UNITED STATES PATENT AND TRADEMARK OFFICE

Office Action Summary

10/572,879

DETAILED ACTION

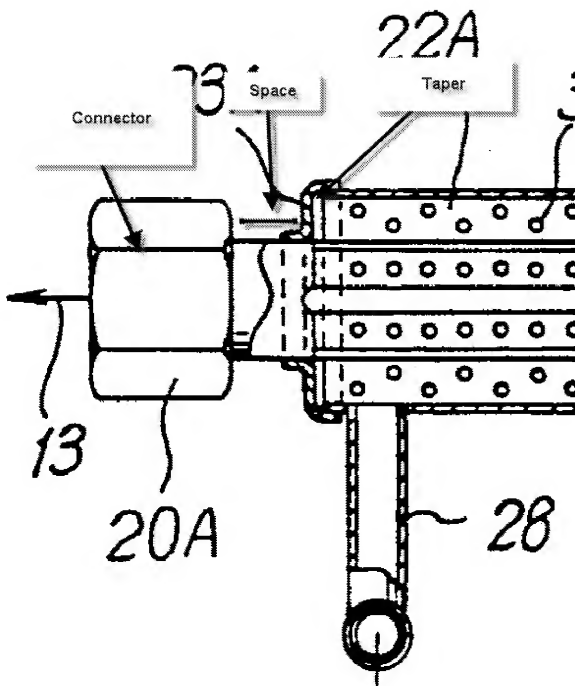
Ostensibly, the added limitation is disclosed in Figure 5 of Watanbe.

Lastly, the specificity found in Applicant's specification particularly the sectional finned structure and the conical structure with members 11, 12, and 17 are not found in the claim language.
